SERVICE BULLETIN MAINTENANCE OF WAY EQUIPMENT

DATE:	4-5-2002			BULLETIN NO:	02-012
TITLE:	RAIL CLAMP ADJUSTMENT SCREW LOCK WASHER SERVICE GROUP				
RATING:		DIRECTIVE (Action Is Required)		ALERT (Potential Problem)	
		INFORMATION (Action Is Optional)	X	PRODUCT IMPROVEMEN (Enhance Product)	Г

PRODUCT SERIES / MODEL: 6700S Tamper

FIGURE 1 RAIL CLAMP TABLE

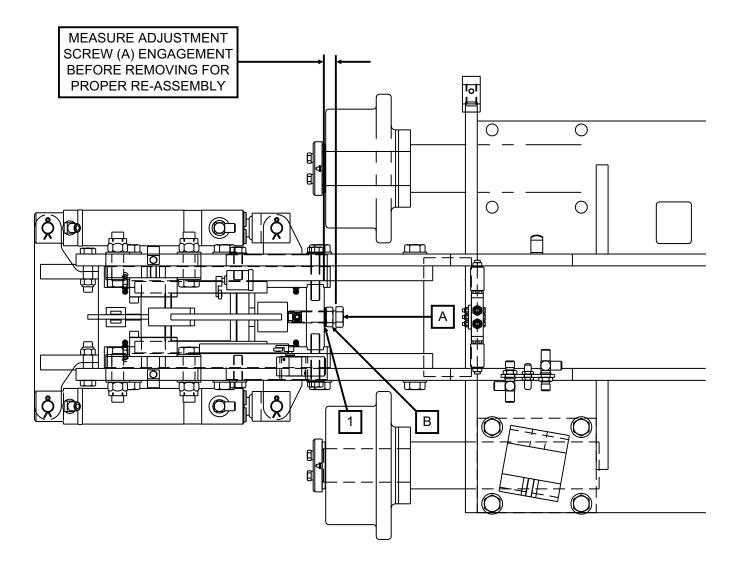
- SERIAL NO: All Models Serial # 153143 thru 153158
- **SUMMARY:** There have been times when the rail clamp adjustment screw controlling the clamp inward travel have loosened due to repeated impact. A Nord-Lock washer part # 2005242 has been added behind the jam nut on all future production machines leaving the Ludington, MI. facility. The Nord-Lock washers are available for retrofitting in the field.

SERVICE GROUP INSTALLATION - See Figure 1

- 1. Locate the existing rail clamp adjustment screws (A) on both sides of the clamp table.
- 2. With the rail clamps retracted, measure the position of the adjustment screw (A) engagement so the screw can be reset to the existing setting upon re-installation.
- 3. Loosen the jam nut (B). Then remove the adjustment screw (A) and jam nut (B).
- 4. Insert a Nord-Lock washer (1) on the end of the adjustment screw (A) so it is against the jam nut (B).
- 5. Re-install the adjustment screw (A). Adjust the screw (A) to the measurement of engagement that was measured in Step 2. Then torque the jam nut (B) to 500 ft-lbs.
- 6. Repeat procedure to install the Nord-Lock washer on the adjustment screw on the other side of the clamp table.
